Re: 102 Broomfield Street Cabramatta (Traffic)– Request for Information (RFI)

This letter contains information regarding the vehicle swept paths, traffic signal operations and vehicle manoeuvrability for the site at 102 Broomfield Street Cabramatta.

BASEMENT 1			
Date of issue 26/11/2020	Checked JE	Approved TJ	
Scale			
AS SHOWN			
@A1 Sheet Size		50mm on original	
Project Number 19-029		Drawing Number Revision DA2002 D	
Status DA SUBMISSION

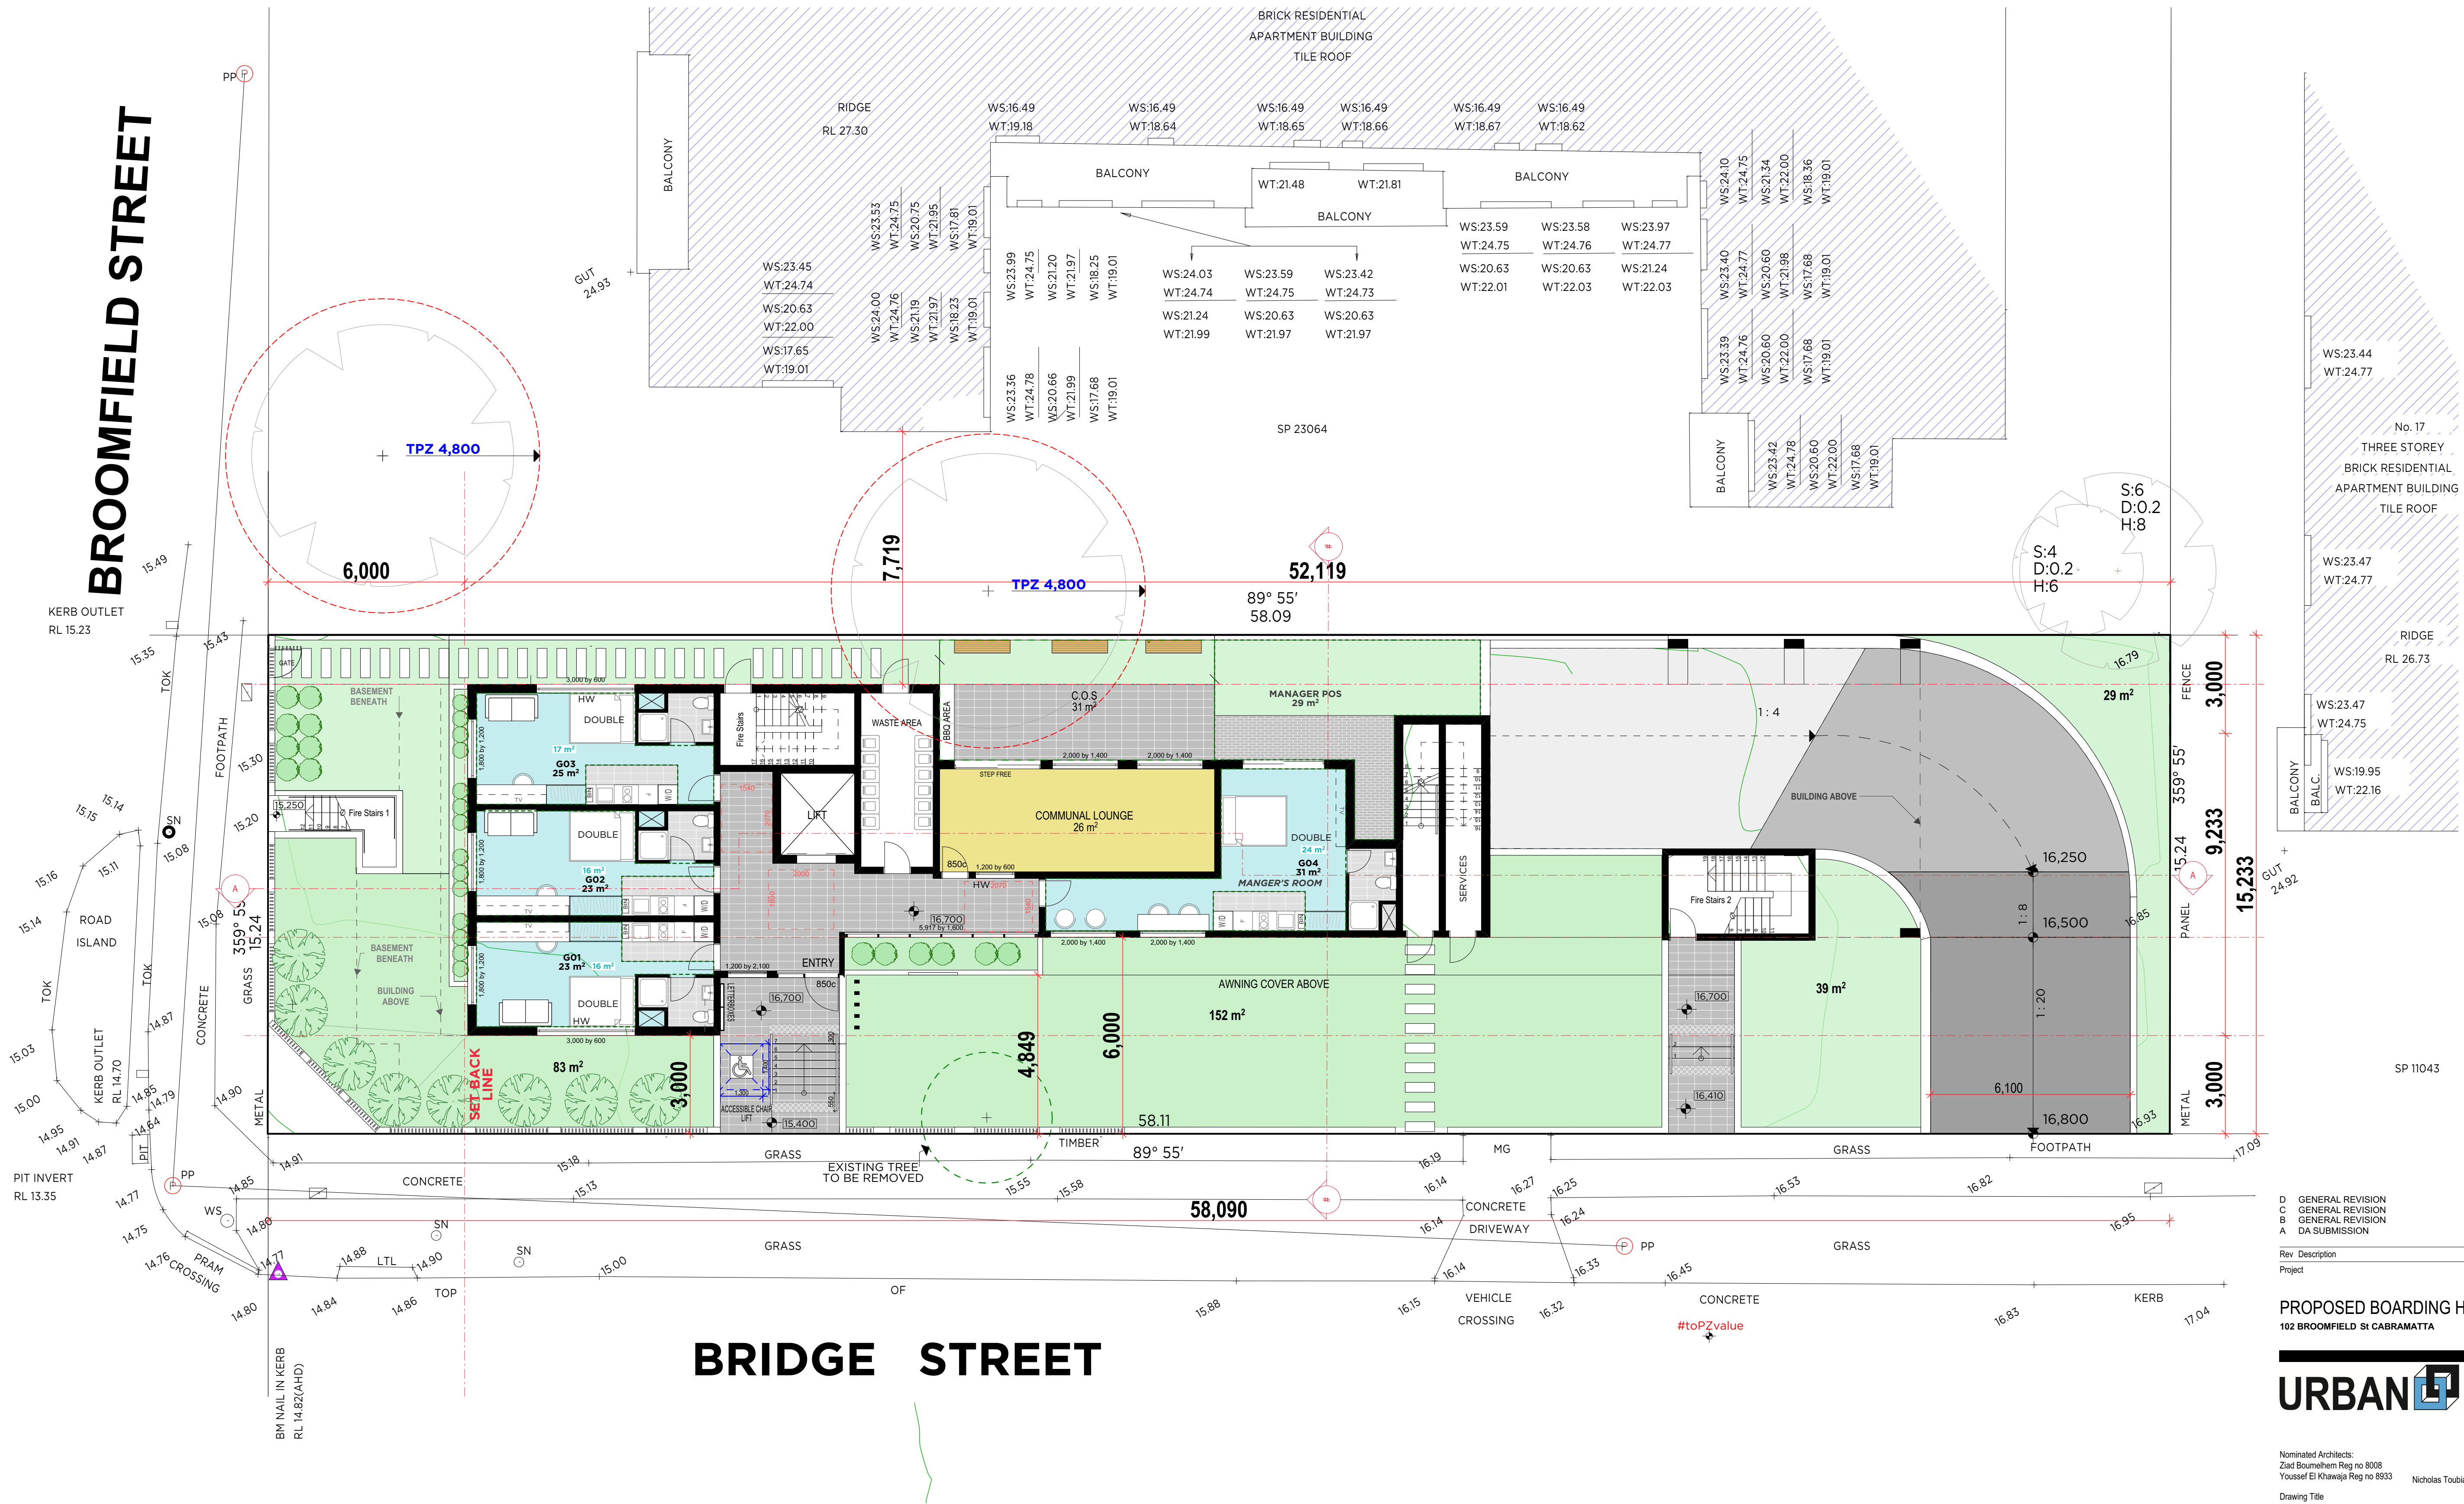
Traffic signals were initially proposed throughout the proposed development from ground level to basement 2. However, the architectural plans (refer to Appendix A) have been revised based on the recommendations by Councils during the consultation on 12th November (2:00pm to 3:00pm), which includes the following:

- Two way ramp from ground level to basement 1
- Traffic signals located on basement 1 and basement 2
- Waiting bay located on basement 1
- One way ramp from basement 1 to basement 2
- Additional signages and line marking to be installed.

To reduce traffic conflicts on basement level 1, the use of convex mirror and signages will be installed to improve the driver's visibility / awareness and minimise traffic conflicts. A plan of management will be prepared to outline the vehicle operations of the site.

In addition, the use of convex mirror and signages will be installed to improve the driver's visibility / awareness and minimise traffic conflicts. A plan of management will be prepared to outline the vehicle operations of the site.

Swept Path Assessment - Basement Level 1
B99 Entry/B85 Exit movements

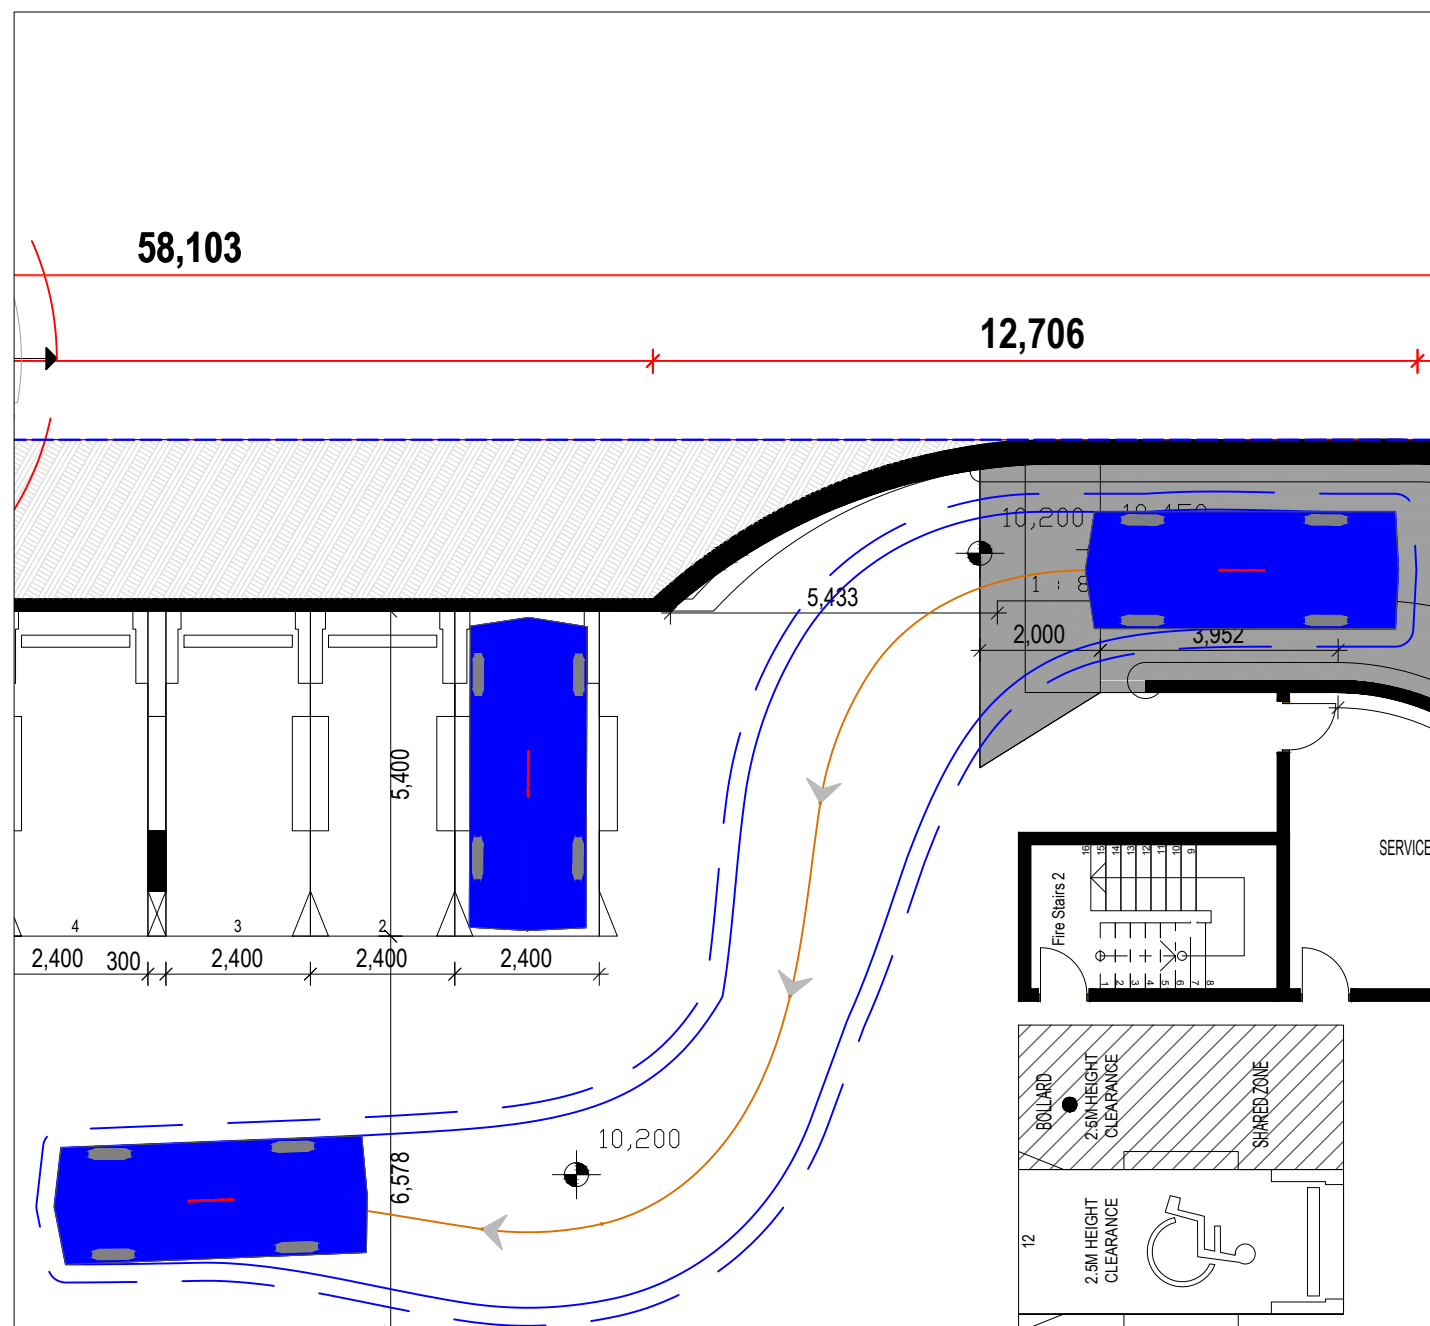
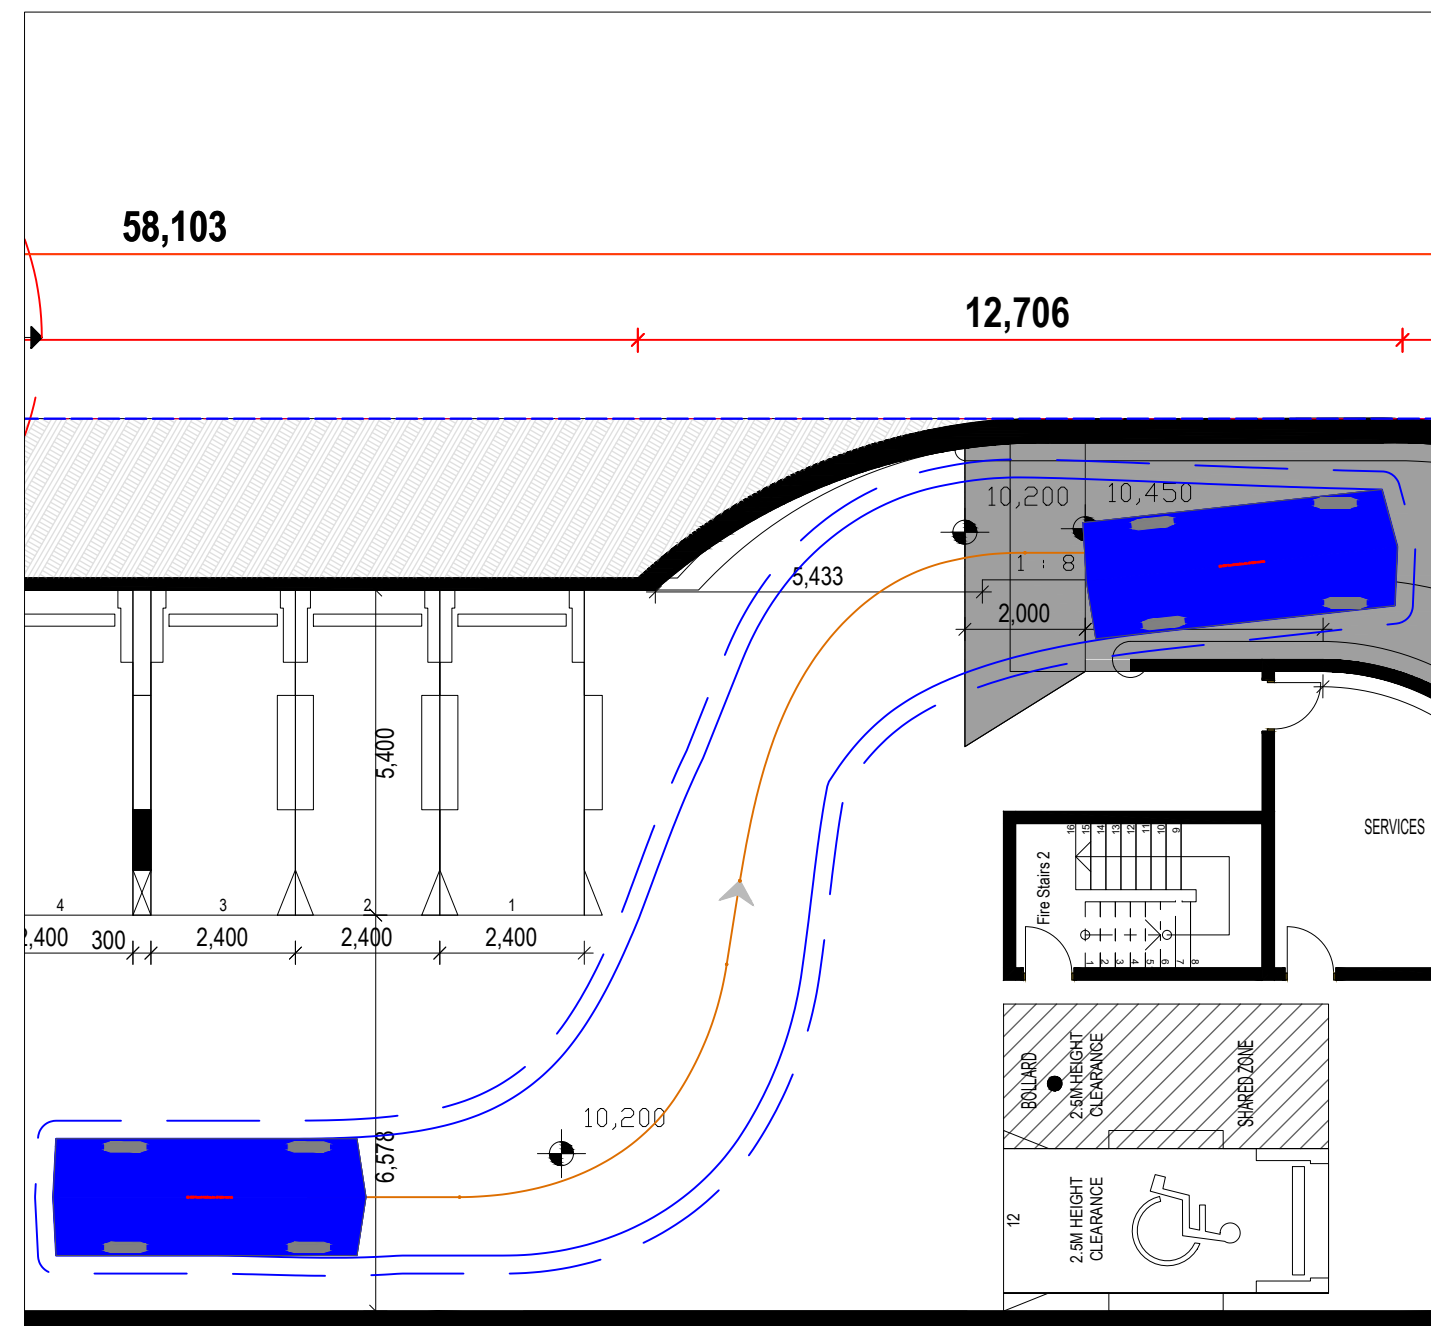
1. Inbound vehicles will enter the site via Broomfield Street
2. Inbound vehicles will be able to access basement level 1 (no traffic signals will be required to access basement 1)
3. In the reverse direction, an outbound vehicle would be able to access the ramp to ground level
4. Outbound vehicle will exit the site via Broomfield Street.
